INCLUDED IN THE SALADO DRAW PAD 3 INCLUDE: SALADO DRAW 18 26 33 #1H SALADO DRAW 18 26 33 #2H SALADO DRAW 19 26 33 #1H SALADO DRAW 19 26 33 #2H API# 30-025-42660 API# 30-025-42661 API# 30-025-42662							
THE SUMMARY ATTACHE	D IS A BRIEF DESCRIPTION OF ELLS LISTED ABOVE.	THE MAIN OPERATIO	NAL SEQUENCES FOR DRIL	LING AND			
IF YOU HAVE ANY QUESTI	ONS, PLEASE GIVE VICENTE	RUIZ /DRILLING ENGIN	IEER A CALL AT 713-898-543	6. KB			
	Electronic Submission #307989	NCORPORATED, sent to CHRISTOPHER WALLS of	the Hobbs				
Cimentum (Planenia	Sub-minning)	Detr. 07/00/0/					
Signature (Electronic	THIS SPACE FOR FE			OVED			
Approved By Conditions of approval, if any, are attach certify that the applicant holds legal or e which would entitle the applicant to com	quitable title to those rights in the subjec duct operations thereon.	office	BUREAU OF LAI	IS Walls			
Title 18 U.S.C. Section 1001 and Title 4 States any false, fictitious or fraudulen	3 U.S.C. Section 1212, make it a crime f t statements or representations as to any	or any person knowingly and matter within its jurisdiction.	willfully to make to any CARLSPAP	Fagency of the United

Changes to APD for Federal Well

Chevron respectfully re

Batch Dalling Segurance

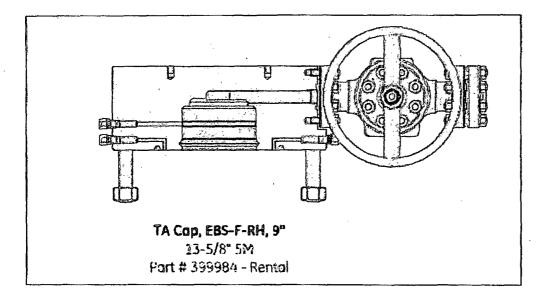
Summary: Variance to batch drill the Salado Draw pad not requested in original submittal.

Variance to batch drill not requested.

Chevron respectfully request the ability to batch drill in the SALADO DRAW (18-19) 26 33 PAD (3^{RD}) . The summary provided is a brief description of the main operational sequences for drilling and casing the four wells listed.
